Subject: RHV Proposed TWY Renaming and RIM/Hotspot Exhibits

Enclosure 1 – County Proposals

Enclosure 2 - FAA's comments and recommendations

Page 2

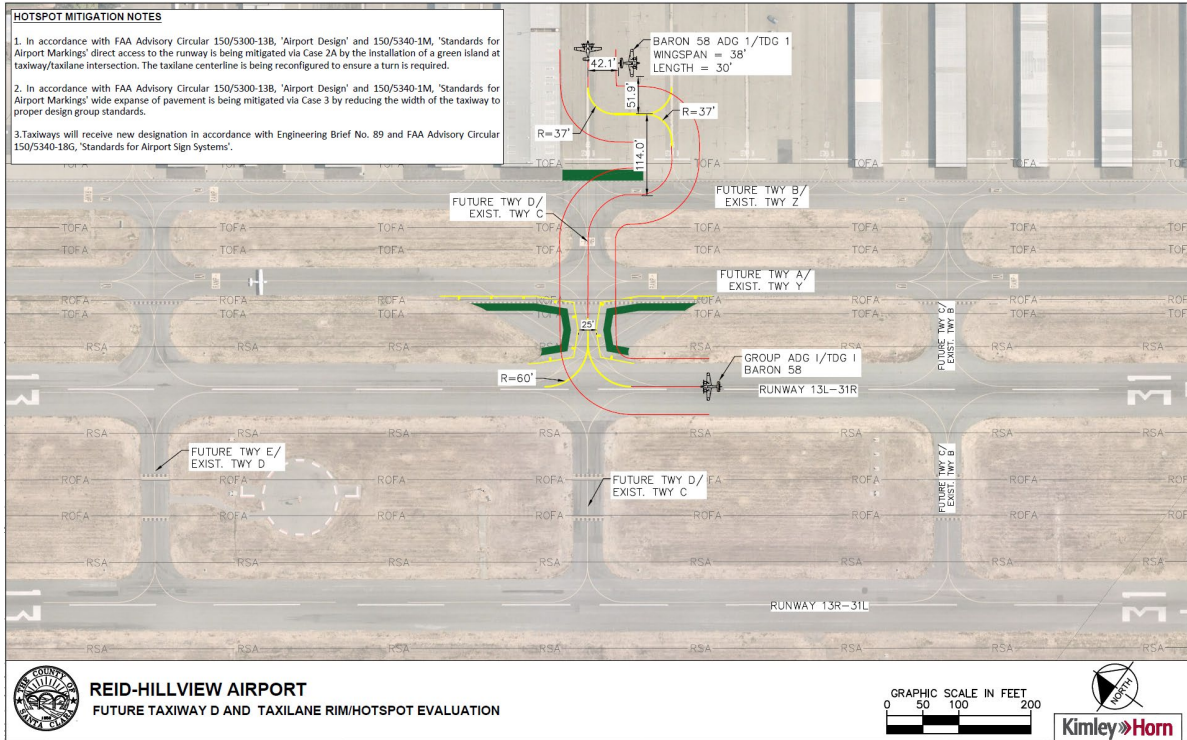
- Page 2 of the email attachment depicts the splitting of the wide expanse of taxiway pavement at the intersection of exiting Taxiway Y, Taxiway A, and the approach end of Runway 31R into two separate taxiways. This is accomplished by the placement of a "no-taxi" island. The County identifies the narrowed taxiway and the new taxiway as Taxiways A1 and A2 in its proposal. Both taxiways meet the applicable width standard of 25 feet, and attain a separation of 74.5 feet, which exceeds the applicable minimum Taxiway Centerline to Taxiway Centerline standard of 70 feet.

The County's proposal narrows the associated segment of the taxiway located between the two runways to the standard width of 25 feet. This eliminates the holding area between the thresholds of Runways 31L and 31R. It also provides for the standard placement of holding position signs on the pilot's side of the taxiway. Eliminating the holding area between the runways removes that portion of the existing hold lines that are closer to the runway than the standard 125 feet. The FAA takes no issue with these proposed standard geometry changes and associated signage changes.

This notwithstanding, the FAA Air Traffic Control Tower (ATCT) is concerned about the elimination of the holding area between the runways. The concern is that the elimination of this area may negatively impact their ability to queue aircraft for Instrument Flight Rules (IFR) departures on Runway 31L. As a result, the FAA recommends the County consider paving an additional standard taxiway segment between the runways (spanning the entire distance from Runway 31L to Runway 31R). The FAA recommends this new segment aligns with the proposed Taxiway identified as A2 in the County's proposal. This provides two standard taxiway entrances and exits from Runway 13R-31L and would provide a way to queue multiple aircraft simultaneously while maintaining consistency with FAA standards.

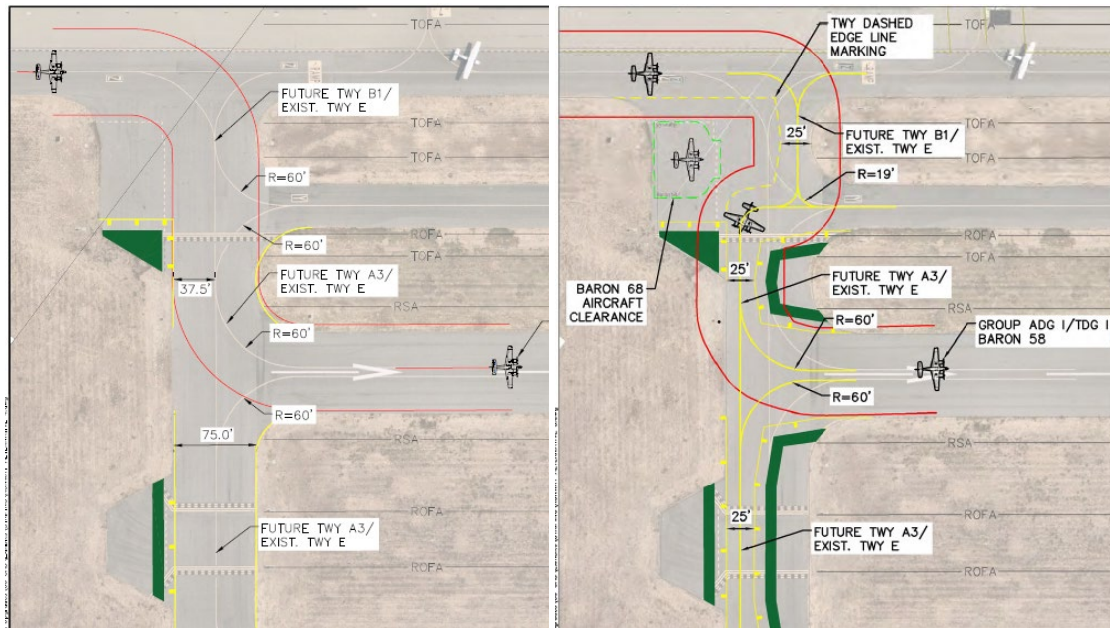
- Pages 4 and 5 of the County's proposal depict two different options for the reconfiguration of existing Taxiway E. The FAA does not concur with the proposal on Page 4 (below left) as it does not narrow the width from the current 75 feet width. The FAA recommends the applicable standard taxiway width of 25 feet.

Page 5 (below right) depicts the narrowing of the subject taxiway segments to standard 25 feet and includes a realignment of the centerline of the taxiway between existing Taxiways Y and Z. As proposed, the realigned Taxiway segment requires a unique taxiway name, shown as Future Taxiway B1.

As an alternative, the FAA recommends consideration be given to narrowing this taxiway segment to the north, in alignment with the remainder of future Taxiway A3 as identified in the County's illustrations above. If this option is chosen, a no-taxi island will need to be installed between existing Taxiway Z and the adjacent parking apron. This no-taxi island eliminates the direct access from the ramp/parking area and the runway. Aircraft exiting the ramp through the remaining exits would then have to make at least two 90 degree turns before reaching the runway hold position for Runway 13L-31R. The placement of such an island eliminates or requires relocation of at least two tie down locations. Note that a similar no-taxi island is proposed for the intersection of Taxiway M and Existing Taxiway Z.

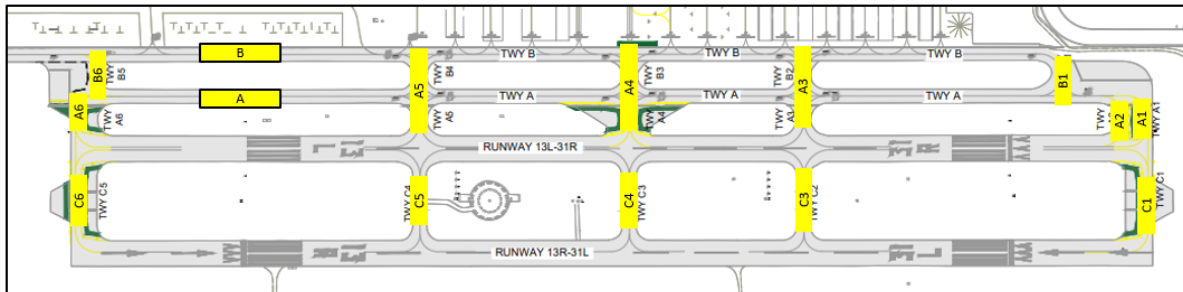
- Using the same taxiway designation for the runway entrance taxiways on both sides of RWY 13L/31R creates a risk for pilot loss of situational awareness due to similar location identifications. To establish positive location identification, we request the end taxiway connector segments between the runways be given unique alphabetic designations.

Applying unique identifiers differentiates those taxiways that fall between the runways on the west side of Runway 13L-31R, from those on the east side of Runway 13L-31R. These taxiways are the busiest runway entry and exit points on the airport and these intersections have experienced the highest volume of runway incursions.

This illustration shows an option that could be used to accomplish this.

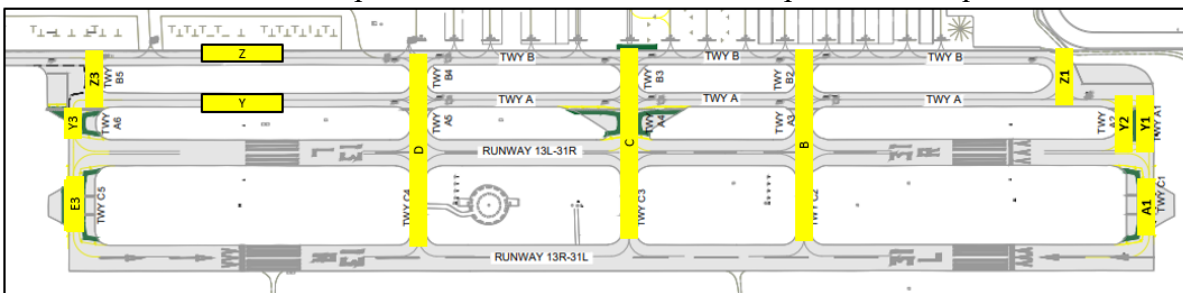
- The FAA Air Traffic Control Tower manager has demonstrated to our office that current taxiways TWY C, TWY D and TWY E are primarily exit taxiways with a high frequency of crossing traffic. FAA does not object to these three taxiways retaining their current designation as this is consistent with FAA standards.

- The FAA's Air Traffic Control Tower manager asked that consideration be given to leaving the parallel taxiways designated as Taxiways Y and Z instead of re-designating them as Taxiway A and B respectively. The rationale for this is to avoid possible confusion with current taxilane and apron area designations (Row Alpha for example). It would also allow for the crossing Taxiways B, C, and D to remain named as is, reducing the learning curve for ATCT personnel and regular airport users. Although retaining the existing TWY Y and TWY Z designations is inconsistent with FAA standards, the FAA believe this inconsistency is of a minor nature and poses little to no risk for loss of situation awareness.

This illustration shows an option that could be used to accomplish these requests.
